# UNITED STATES PATENT AND TRADEMARK OFFICE

APPLICATION NO.	FILING DATE	FIRST NAMED INVENTOR	ATTORNEY DOCKET NO.	CONFIRMATION NO.
09/232,119	01/15/1999	THILO WEITZEL	298-73	2187

# Office Action Summary

## DETAILED ACTION

Fig. 2

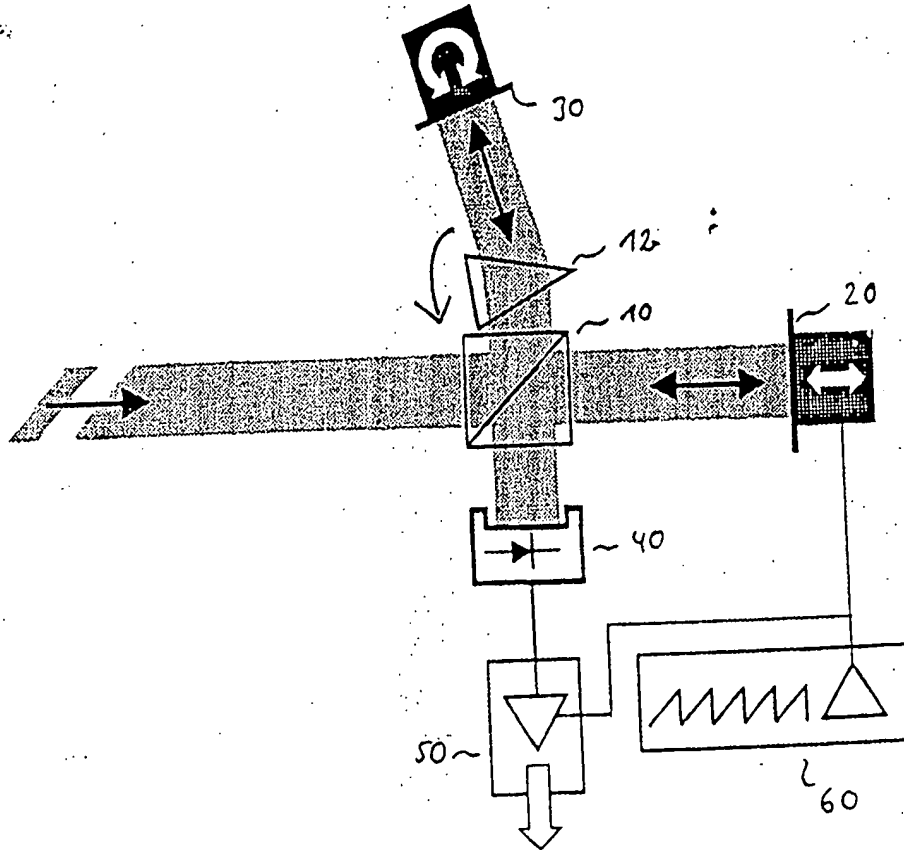
2. Applicant's compliance with the objections to the drawings in the previous Office Action (mailed on 17 May 2005) is noted and appreciated. A replacement drawing sheet for Fig. 2 and a new sheet for Fig. 5 were received on 21 November 2005. Fig. 2 is approved. Fig. 5 is disapproved. Fig. 5 shows structural details of a coupler and a fiber, but these structural details and this fiber is not taught in the disclosure. As a remedy, Examiner respectfully suggests replacing the coupler and fiber of this Fig. 5 with a generic box indicating the coupler in replacement drawing sheet for Fig. 5.

However, notice prism 12 in Applicant’s Fig. 2. According to the general understanding of prisms with such a shape, prism 12 would spatially separate optical channels of different wavelengths from each other. Then, after reflection from mirror 30, these channels would travel back through prism 12. However, due to the initial spatial separation of the optical channels and the angular relationship between prism 12 and mirror 30, any single, detected, optical channel with a defined wavelength would be spatially separated from other optical channels of different wavelengths. Thus, the disclosure does not teach this “without spatial separation” limitation.

Additionally, this “without spatial separation” limitation is not enabled by the disclosure. It appears that the “detection of a single optical channel with defined wavelength” depends on these features of Applicant’s invention: the initial spatial separation of the optical channels and the angular relationship between prism 12 and mirror 30. That is, the “detection” feature of Applicant’s invention ***depends***, at least, on spatial separation of the optical channels. Thus, there is conflict between this operating principle (the spatial separation) of Applicant’s invention in Fig. 2 and the “without spatial separation” language of

Notice that claims 54-55 include “**heterodyne**” detection. However, the discussion of the embodiment of Fig. 2 (e.g., p. 10, 1<sup>st</sup> paragraph) does not expressly disclose “heterodyne” detection. Consideration of the technical aspects of Applicant’s Fig. 2 leads one to wonder whether or not Applicant’s Fig. 2 actually involves “heterodyne” detection.

Next, let us consider Applicant’s apparatus in Fig. 2. It appears that Applicant’s apparatus in Fig. 2 functions by arranging the mixing, or interference, two electromagnetic waves: (1) the reference light from mirror 20 and (2) a particular portion (i.e., wavelength/frequency) of the spectrum of the light from mirror 30. The reference light has a frequency spectrum that is relatively broadband. The light from mirror 30 has the same spectral (frequency) components as the reference light and is also broadband. However, the particular arrangement of mirror 30 and prism 12 arranges the relevant interference of only a particular portion (i.e., wavelength) of the spectrum of the light from mirror 30 with the broadband spectrum of the reference light. Note that the wavelength of this particular portion (i.e., wavelength) of the spectrum of the light from mirror 30 is **included** in the broadband spectrum of the reference light.

Approved by DSK  
26 January 2006

Fig. 5, showing the coupler

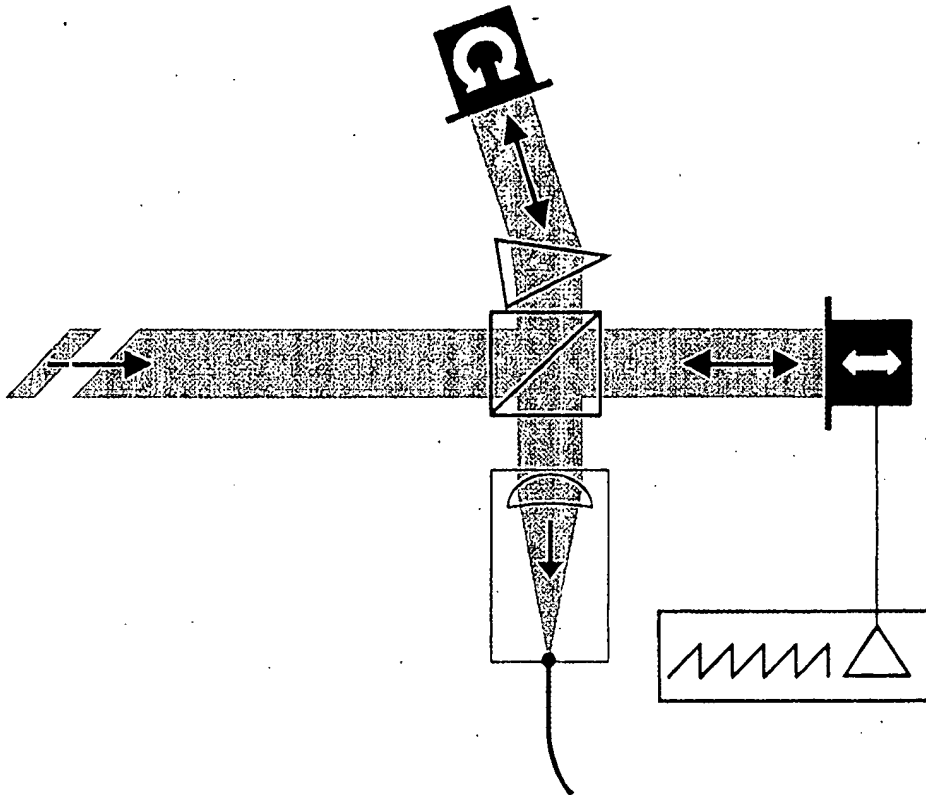
Disapproved by DSK
